INTELLIGENT PANEL SYSTEMS

IPS-SPL-001 | Revision 1 | 17 October 2026 | Spline section dimensions

150 mm former family only. Dimensions in mm. Diagrammatic - do not scale. Other approved details unchanged.

OPTION 2 - TR26 TIMBER SPLINE

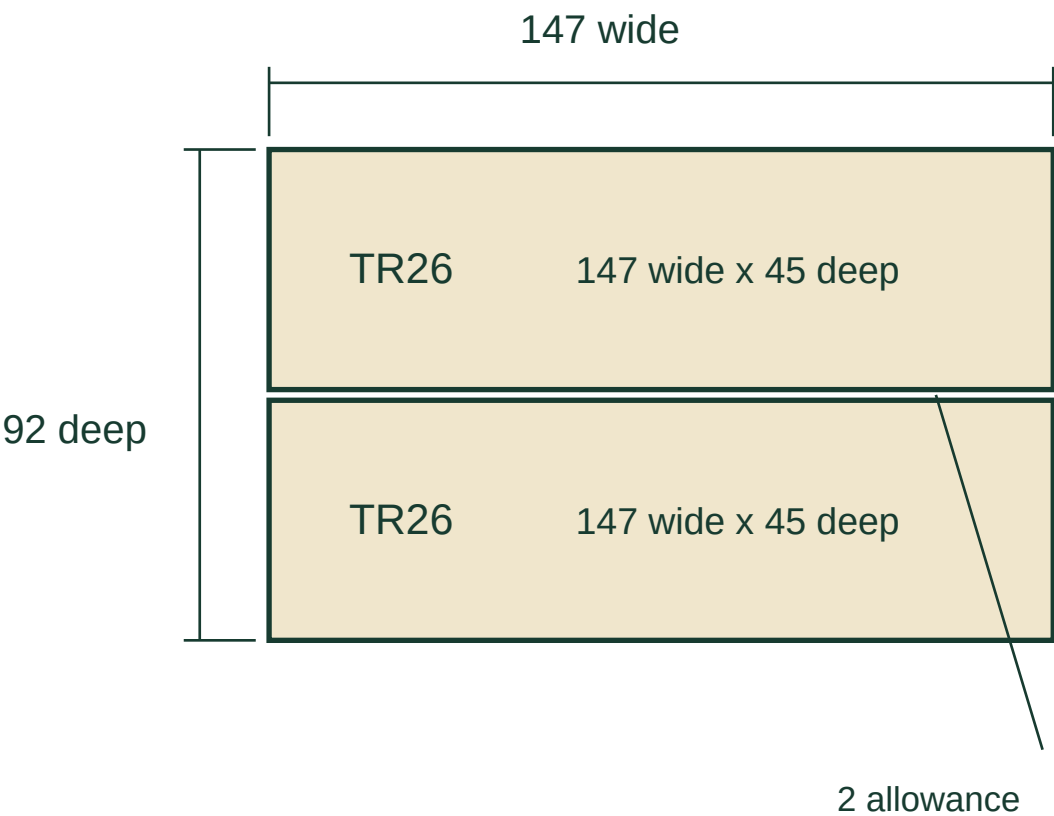
PROCUREMENT HOLD - TR26 AT EXACT FINISHED 147 x 45 mm

Exact supply not confirmed. Published TR26 examples are 147 x 46.5 mm; two plus 2 mm would total 95 mm.

2 x 147 x 45 TR26 members

45 + 45 = 90 deep; 90 + 2 allowance = 92 deep.

Obtain written finished-size, tolerance, grade and availability confirmation. No substitute or site resizing is approved.
